Title - Sujet Highway Construction Km 555.64	
Solicitation No. - N° de l'invitation EZ899-142382/A	Amendment No. - N° modif. 003
Client Reference No. - N° de référence du client	Date 2014-03-25
GETS Reference No. - N° de référence de SEAG PW-\$PWY-030-7217	
File No. - N° de dossier PWY-3-36299 (030)	CCC No./N° CCC - FMS No./N° VME
Solicitation Closes - L'invitation prend fin at - à 02:00 PM on - le 2014-04-02	Time Zone Fuseau horaire Pacific Daylight Saving Time PDT
F.O.B. - F.A.B. Plant-Usine: <input type="checkbox"/> Destination: <input checked="" type="checkbox"/> Other-Autre: <input type="checkbox"/>	
Address Enquiries to: - Adresser toutes questions à: Dobson (PWY), Krista	Buyer Id - Id de l'acheteur pwy030
Telephone No. - N° de téléphone (604) 775-7088 ()	FAX No. - N° de FAX (604) 775-7672
Destination - of Goods, Services, and Construction: Destination - des biens, services et construction: PWGSC - Alaska Highway Construction KM 555.64-560.78 and KM 563.1-570.2

This amendment is raised to respond to questions from potential bidders and to modify the ITT as per attached.

**The following changes/clarifications in the tender documents are effective immediately.
This addendum w

R.017173.049
 12 DECEMBER 2013
 C51
 OF

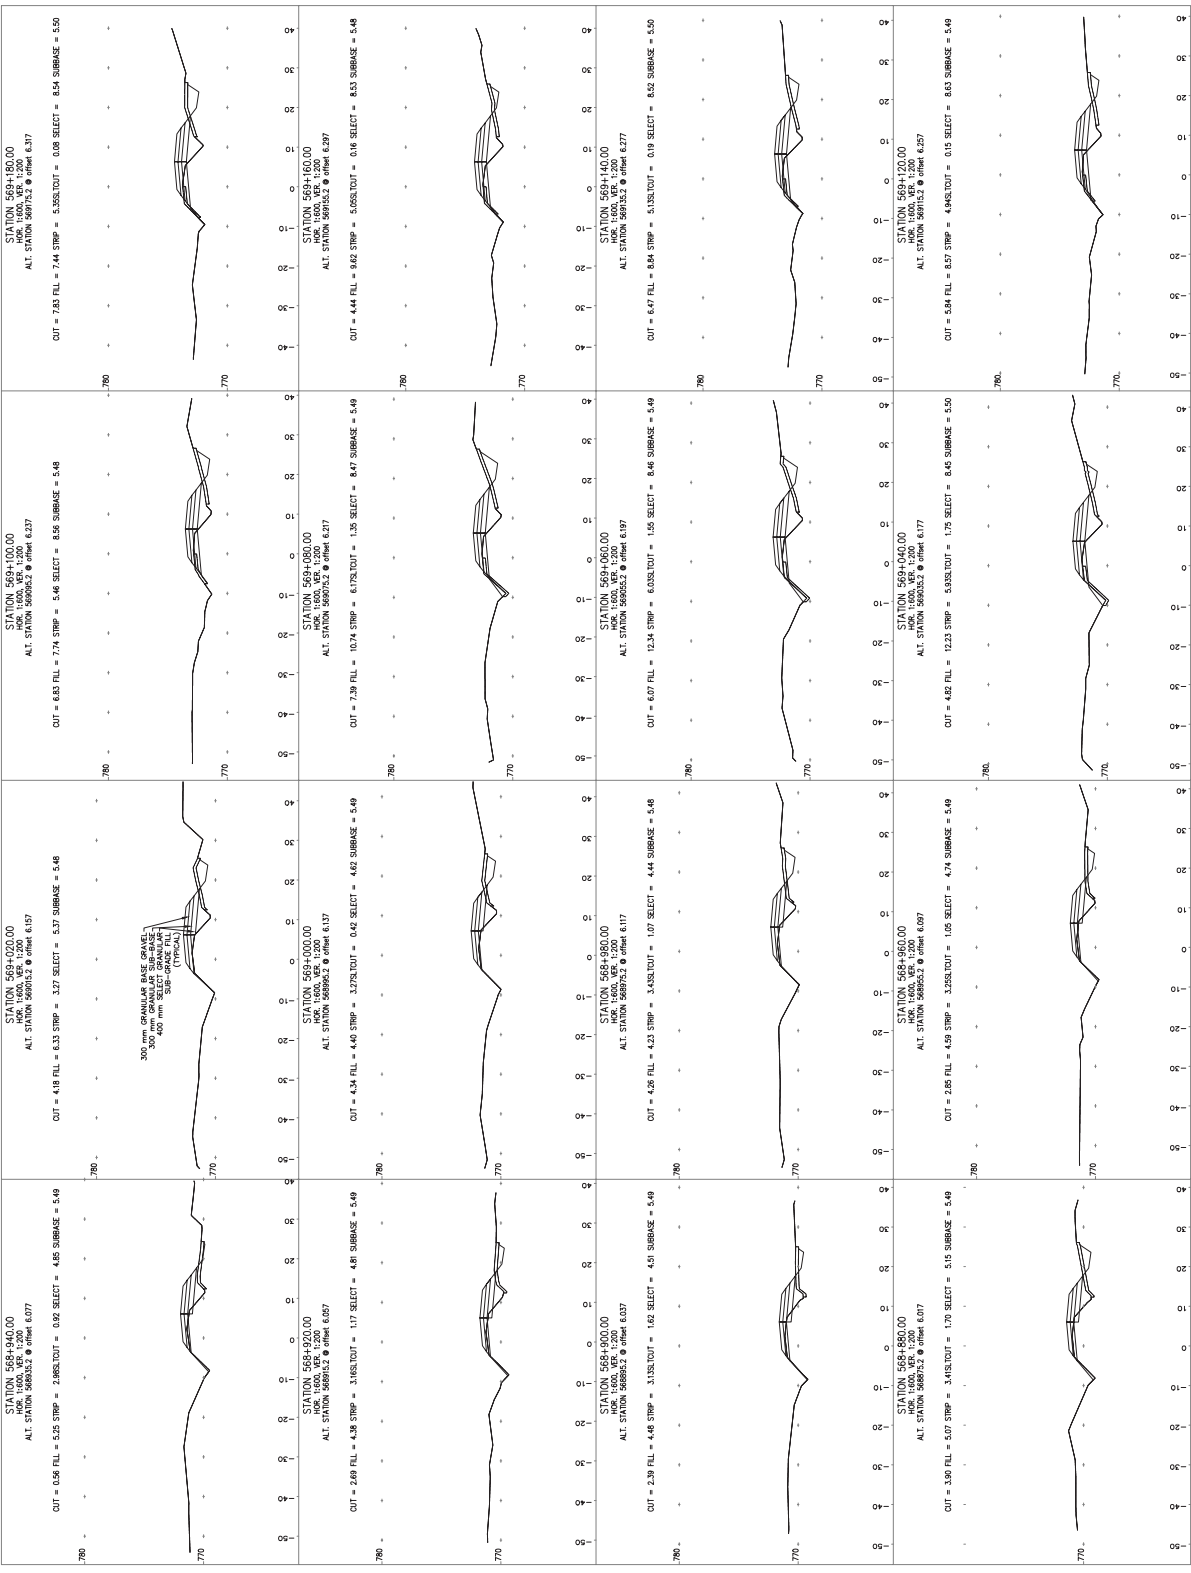
Also, The drawings included a duplicate of drawing C50 in place of C51. Please see C51 attached.
